# UNITED STATES PATENT AND TRADEMARK OFFICE

APPLICATION NO.	FILING DATE	FIRST NAMED INVENTOR	ATTORNEY DOCKET NO.	CONFIRMATION NO.
10/005,129	12/07/2001	Hiroshi Takeuchi	MIT-024-USA-P	8052

**Office Action Summary**

## **DETAILED ACTION**

FIGURE A (TORAN)

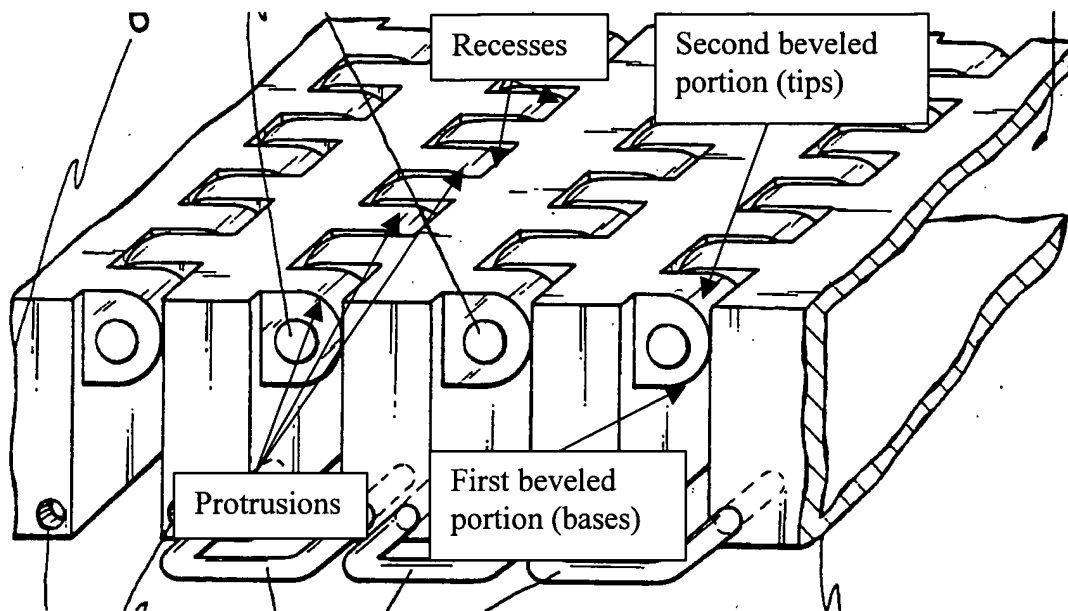
As to **claim 1**, TORAN discloses a bendable bottom member of a bed comprising a plurality of side by side bars 8 bendably connected with each other to allow the whole extent of the connected bars to be curved, said bars being disposed generally perpendicular to the longitudinal axis of the bed, one of every adjacent two of the bars is provided with a plurality of longitudinal connecting protrusions being generally perpendicular to the longitudinal axis of the bed, while a plurality of recesses are formed in adjacent bars for accepting protrusions extending from an adjacent bar, in such a manner that the connecting protrusions of the bars can be inserted into corresponding recesses of an adjacent bar said protrusions having at tips and bases thereof first and second beveled portions, respectively, forming clearances between the protrusions and corresponding recesses to allow the connecting bars to be bent in one direction and disengagement preventing means 35 formed at a tip of some of the connecting protrusions. FIGURE A better shows the cited structures of TORAN and is depicted below. While TORAN discloses side by side bars 8, they fail to show the ability to be shortened and extended; while TORAN discloses disengagement preventing means 35, they fail to show disengagement preventing means comprising hooks formed at a tip of some of the connecting protrusions; while TORAN discloses corresponding accepting recesses, they fail to show corresponding accepting recesses having steps therein adapted to engage the hooks, so that the hooks and steps are engaged with each other when the respective adjacent bars are kept furthest away from each other; as recited in the claims. SHIRAI teaches a bottom structure of a bed similar to that of

As to **claim 3**, TORAN discloses first beveled portions are formed on lower sides at the tips of the connecting protrusions while second beveled portions are formed on the upper sides at the bases of protrusions, to use the bendable bottom member as a bendable portion between the back region and the waist region. See FIGURE A above.

As to **claim 4**, TORAN discloses first beveled portions are formed on the upper sides at tips of connecting protrusions, while second beveled portions are formed on lower sides at the bases of protrusions, to use the bendable bottom member as a bendable portion between the waist region and the leg region. See FIGURE A above, but reverse the labels of first and second beveled portions. Claims 3 and 4 are not interdependent and so the alternative interpretations are valid.

As to **claim 5**, TORAN discloses the second beveled portions at the bases of the connecting protrusions are inclined in adaptation to the desired bending angles with the adjacent bars. See FIGURE A above.
